## ADDENDUM NO. 6

# LIBERTY ELEMENTARY SCHOOL RENOVATIONS Chesterton, IN 46304

**Addendum Three (AD.06)** to the drawings and specifications prepared by Gibraltar Design for **Liberty Elementary School Renovations** for Duneland School Corporation, Chesterton, Indiana.

M-501

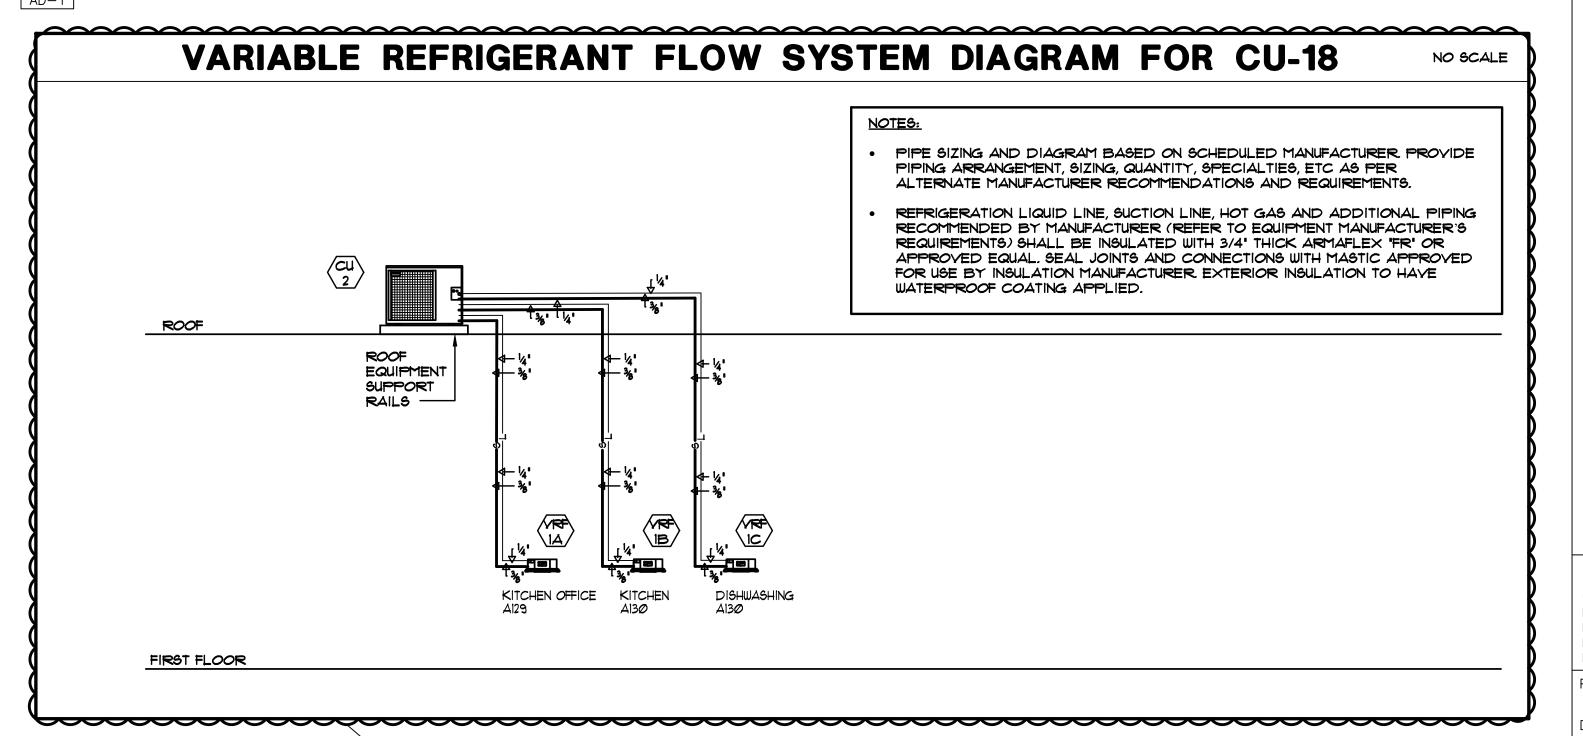
- A. Refer to revised full size drawings, included in this Addendum, for the following revisions:
  - 1. Added VRF diagram.
  - 2. Added VRF schedule.
  - 3. Added VRF condensing unit to mechanical equipment schedule.

E-604

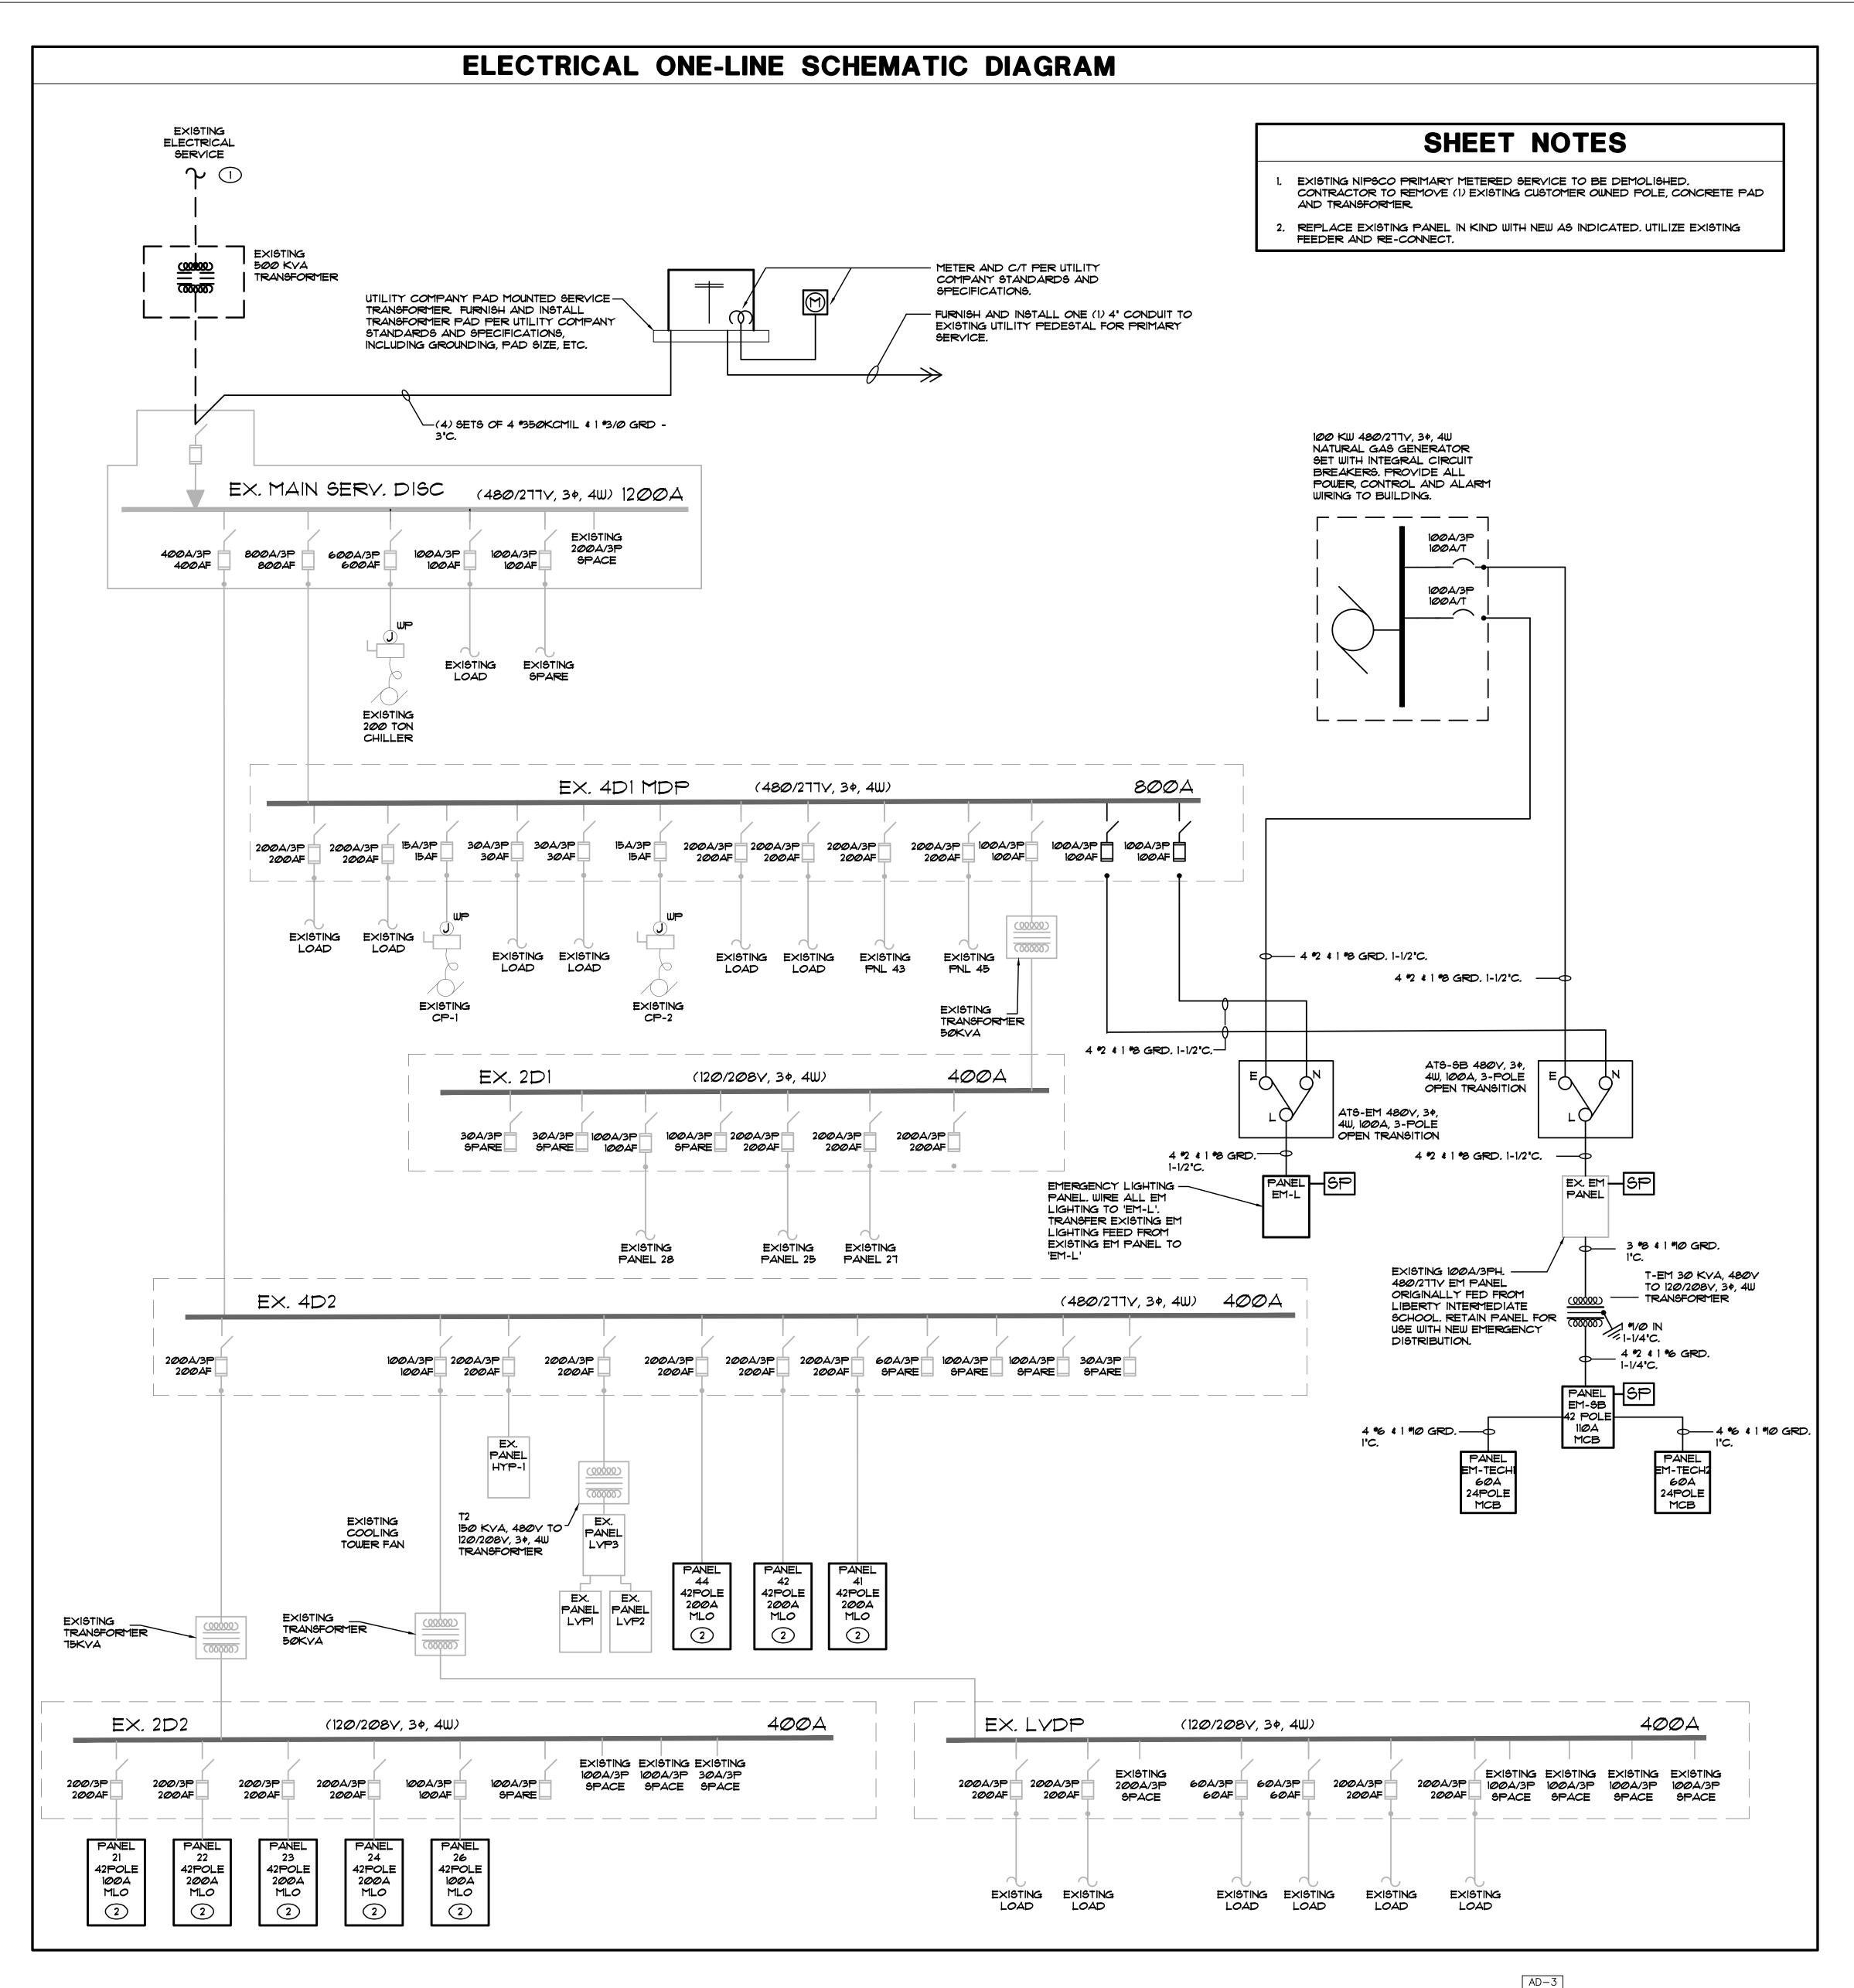
- A. Refer to revised full size drawings, included in this Addendum, for the following revisions:
  - 1. Revised one-line diagram to for clarification.
  - 2. Panel 26 added to one-line diagram (originally shown on floor plans).
  - 3. Add Panel schedules for entirely new panels, excludes replacement panels as they are noted on one-line.
